APPLICATION No: P21/S3961/CM, (MW.0115/21)

**Further information required to support planning application and under
Regulation 25 of the Town and Country Planning
(Environmental Impact Assessment) Regulations 2017:**

**Proposed Sand and Gravel Extraction on
Land at White Cross Farm, Wallingford**

Drainage Information Requested by Oxfordshire CC- March 2022

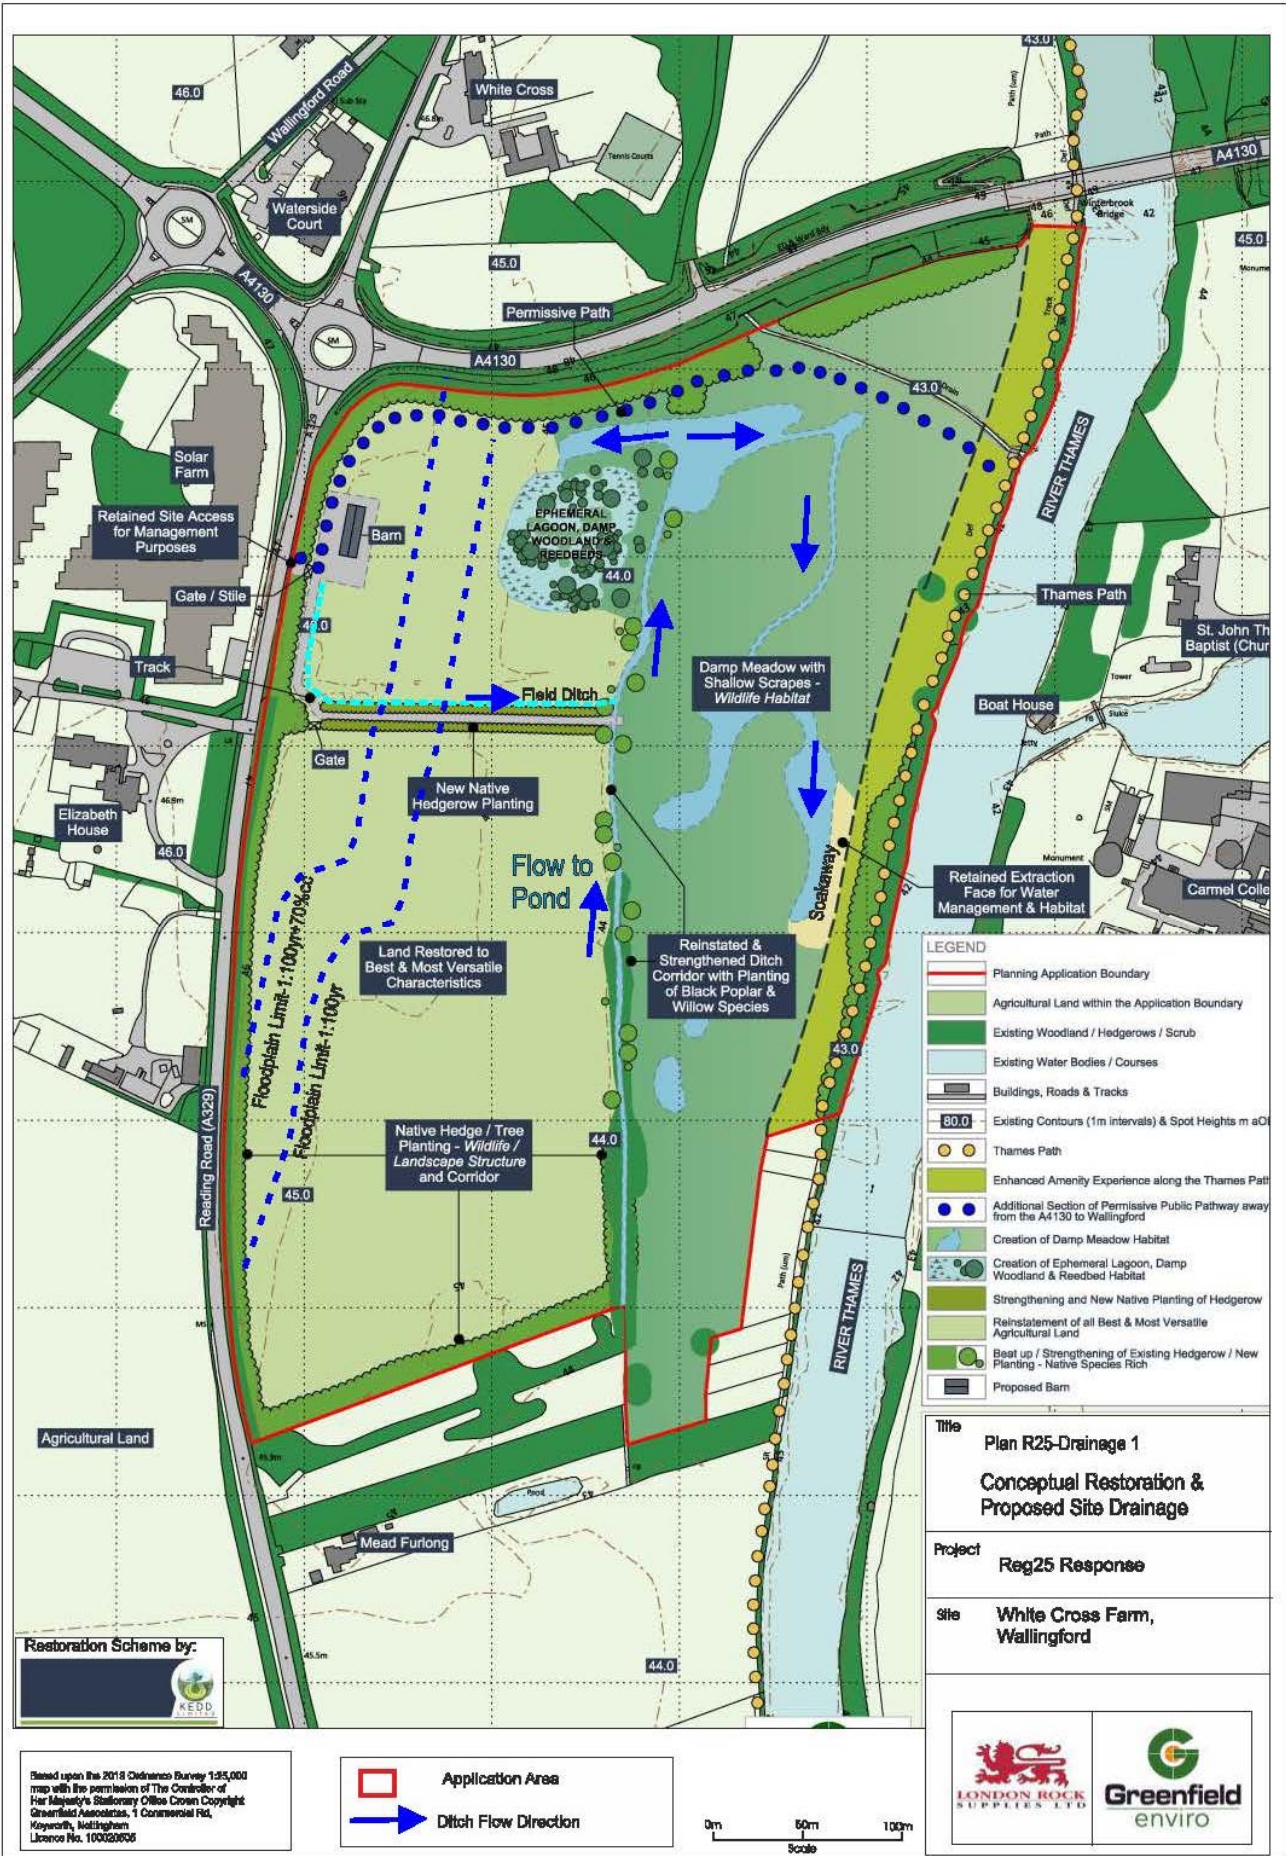
3. Calculation files demonstrating that surface water flow will be maintained to Greenfield discharge rates for all relevant return periods, including a 40% Climate Change allowance

The restoration of the quarry site will be back to original levels, with the soils replaced to allow the existing mix of agricultural arable farming land and floodplain grazing grassland adjacent to the River Thames, with the additional habitats that are typical of the Thames Valley that increase the biodiversity of the site. These additional habitats include "damp meadow with shallow scrapes" together with ephemeral ponds, damp woodland and reed beds. The proposed restoration scheme is shown in Plan R25-Drainage 1 below.

The inclusion of a small lagoon/ pond in the areas of the silt lagoon will enhance the biodiversity of the scheme and also form a collection point for surface water run-off that will issue into the central (north-south trending) ditch. The southern part of this central ditch will be retained with the hedgerow and will be re-instated northwards in it's original "pre-development" location and elevation.

The proposed restoration with the additional low-lying wetland areas, with the extended range of floodplain habitats, will increase the biodiversity of the site and also assist with the surface water drainage to reduce the discharge from the site compared with the current (pre-development) site.

A simple plan showing only the drainage system (as part of the proposed site restoration) is given below as Plan R25-Drainage 2.

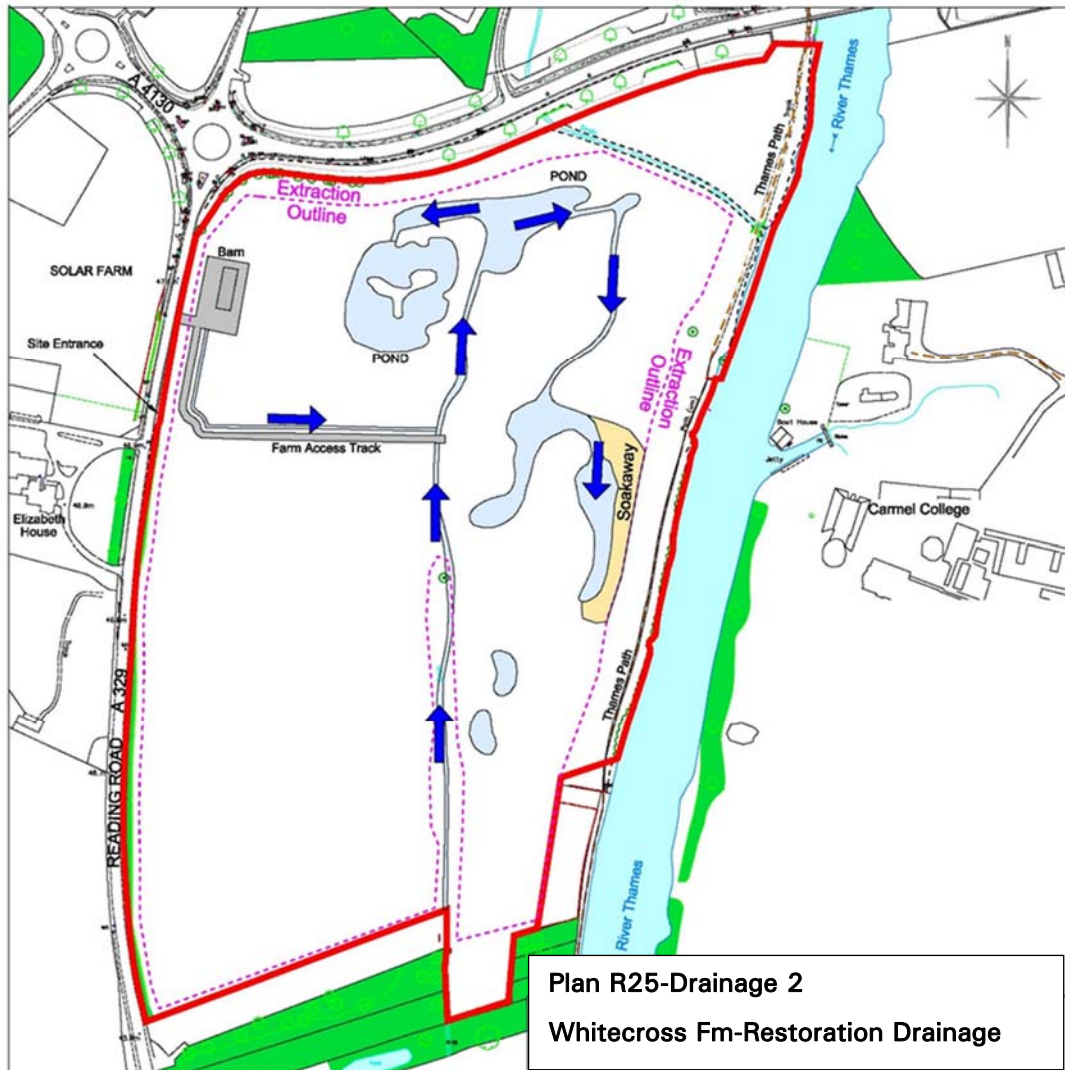
4. A plan showing where surface water flow paths will go once works to following restoration

The restoration scheme, with surface water flow paths are shown in Plan R25-Drainage 1 (above).
